Inter-Office Memorandum

Date: December 2, 2011

Subject: Revised Urban Street Typical Section
Figures 14-2H and 14-2F in 2001 Roadway Design Manual

TYPICAL SECTION NOMENCLATURE
(URBAN STREETS WITH CURBS)
FIGURE 14-2H
(REVISED)

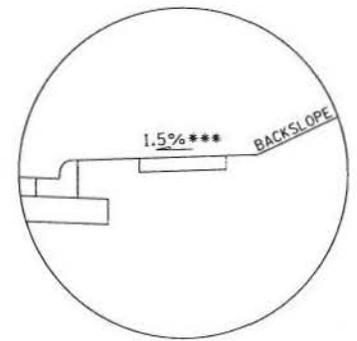
1. The 2% slope across the sidewalk is reduced to 1.5% desirable, with 2% being the maximum allowable slope. A 1.5% cross slope will adequately drain the surface and provide some construction tolerance.
2. The fill section on the right side of the current figure shows a 2% slope across the sidewalk sloping towards the roadway. The revised figure shows the sidewalk sloping in the opposite direction, away from the roadway. The purpose of this is to reduce the amount of drainage entering into the stormdrain system. A fill ditch is also shown to carry side drainage to the next cross-drain.

3. The cut section shown on the right side of the current figure also shows the area behind the curb sloping towards the roadway. While this method is acceptable, it is more desirable to have this area sloping away from the roadway also, which would require that a ditch be incorporated behind the curb & gutter and sidewalk as shown in the revised figure. However, this may not always be practical in urban sections due to Right-of-Way constraints, and should be evaluated on a case-by-case basis. See Detail A in the revised figure.

4. In cases where it is not practical to design according to item number three above, and where alternating fill and cut sections would result in alternating directions of the slope of the area behind the curb, it is acceptable to slope this area towards the roadway as shown in Detail A of the revised figure, even in the fill sections. However, the stormdrain system for the roadway shall be designed so that this additional drainage can be accommodated (additional inlets, larger stormdrain pipes, etc).

5. The fill section on the left side of the current figure is shown correctly. However, without the sidewalk the slope should be 4%. Once again, an attempt should be made to slope the area behind the curb away from the roadway in both cut and fill sections, and incorporate a ditch behind the curb & gutter as described in item number three above, and as shown in the revised figure.

6. The ditches shown in the revised figure are minimum, and shall be adjusted as necessary to provide adequate drainage.
7. The left side of the current figure shows a desirable width of five (5) feet for the area behind the curb. A three (3)-foot width is acceptable here.

8. The right side of the current figure shows a three (3)-foot desirable buffer width between back of curb and sidewalk. The desirable buffer width should equal the driveway radii. It should be noted the Design Manual states that the minimum turning radius is three (3) feet for residential driveways, and five (5) feet for commercial/industrial driveways, measured from the back of the curb. Preferably, these minimum radii should be increased to five (5) feet and ten (10) feet respectively,

TYPICAL URBAN DRIVEWAYS
FIGURE 14-2F
(REVISED)

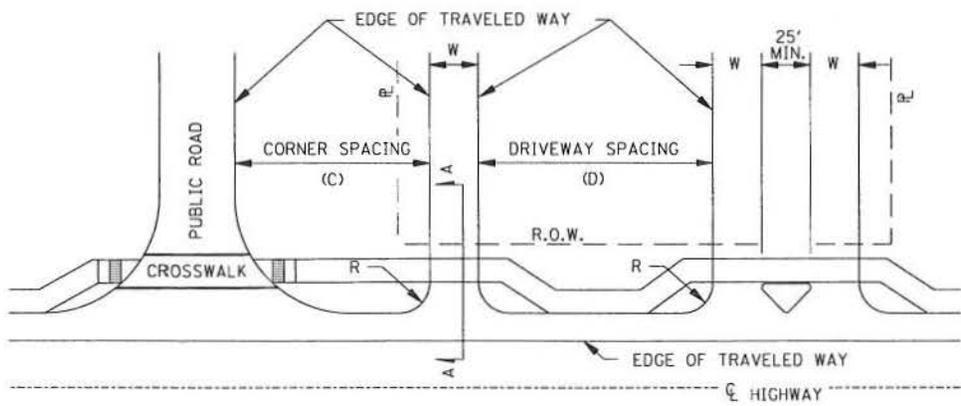
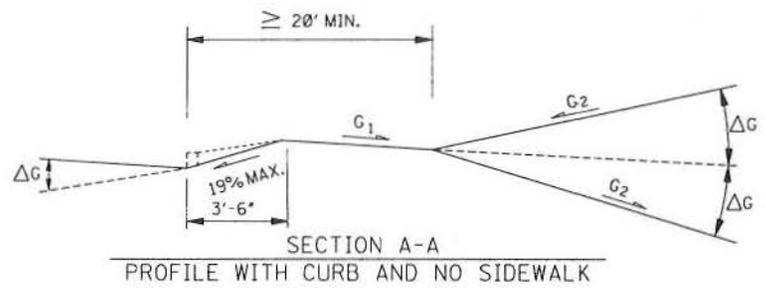
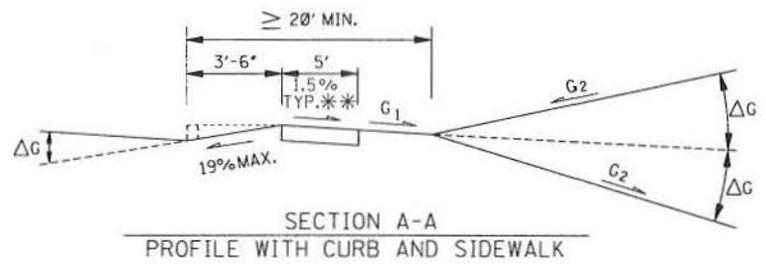
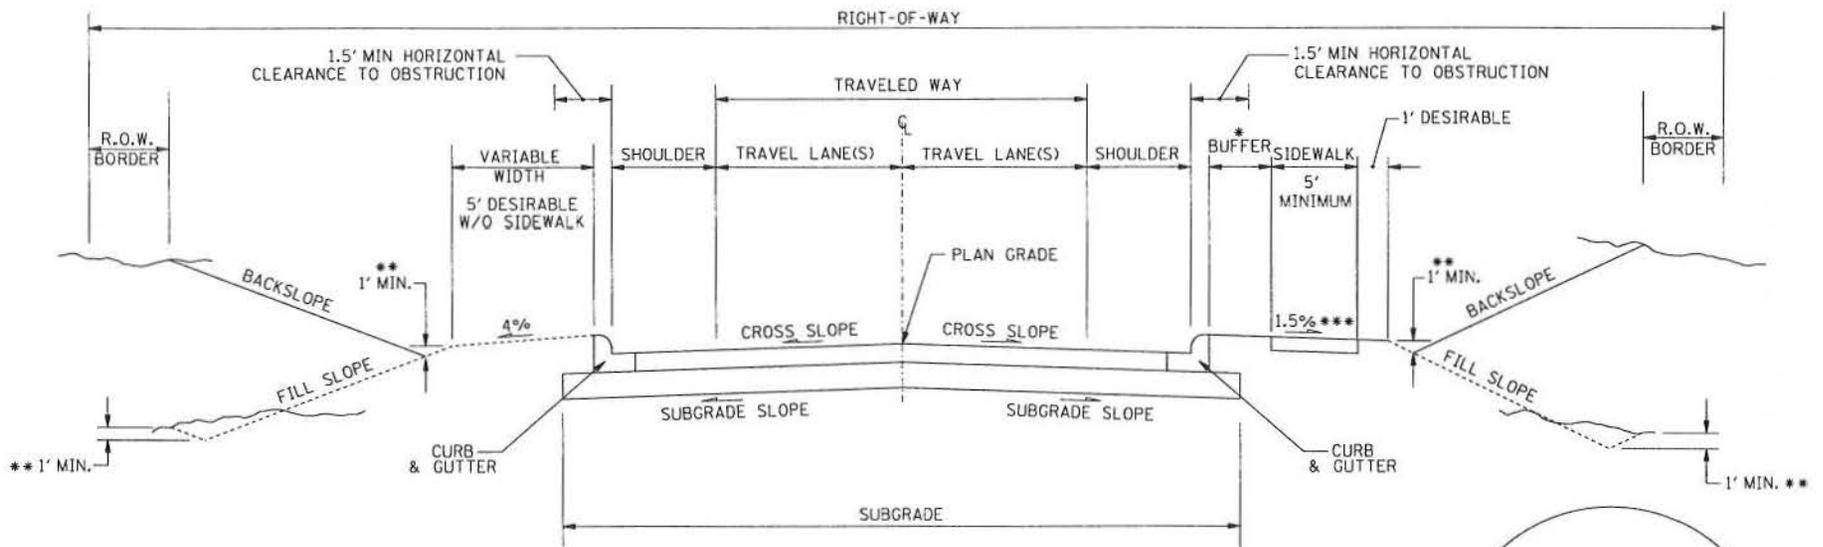
A revised Figure 14-2F is also attached. This revision incorporates the changes described above to the profile sections, and also revised plan views for different sidewalk configurations.
